Rule Change Notice: Capacity Credit Allocation Methodology for Intermittent Generators (RC_2018_03)

Submitter: Fan Zhang, Collgar Wind Farm (**Collgar**)

Date submitted: 1 March 2018

Rule Change Proposal ID: RC_2018_03
Date received: 1 March 2018

Figure 1: LSG intervals by time period 2012 - 2017

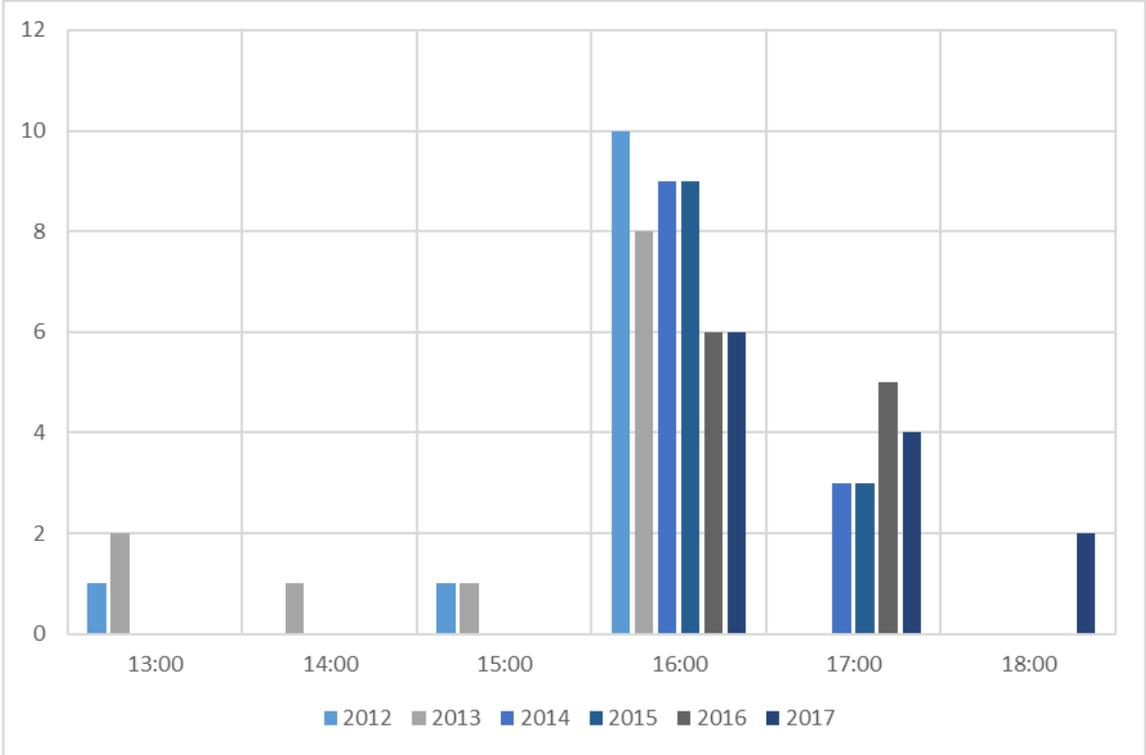
With the increasing penetration of rooftop Photo Voltaic (PV) systems installed behind the meter the traditional peak times in the middle of the day are being shifted to later periods in the day. This is illustrated in Figure 1, showing LSG intervals increasingly shifting to the later Trading Intervals in the day¹. Some LSG intervals in recent years have even shifted out of the traditional peak period with LSG intervals occurring for example on 8 June 2016 and 12 July 2016. LSG intervals are no longer necessarily falling in similar periods to IRCR intervals and therefore do not represent a reasonable representation of the ability of intermittent generators to provide capacity support to the system during the true peak periods on the system when such support is of most value.

One of the stated objectives when introducing the LSG concept in the WEM Rules was to put in place a methodology that more accurately recognised the contribution of PV to overall system capacity. With LSG periods shifting to 5 pm and later, this will impact significantly in a negative direction on solar farms in particular, despite these facilities generally being available with high capacity factors during the traditional peak periods where the underlying “gross” demand on the system is at the highest.

Collgar Wind Farm believes that as a first step in rectifying the methodology for allocating Capacity Credits to intermittent generators the concept of LSG in the WEM Rules need to be removed and replaced with intervals selected from the actual system peak periods. This will provide a more direct link between the requirement for capacity in peak periods and the ability of intermittent generators to provide capacity during those periods of the highest demand on the system. Collgar Wind Farm considers this will be an important step in addressing discrimination against intermittent generation technologies.
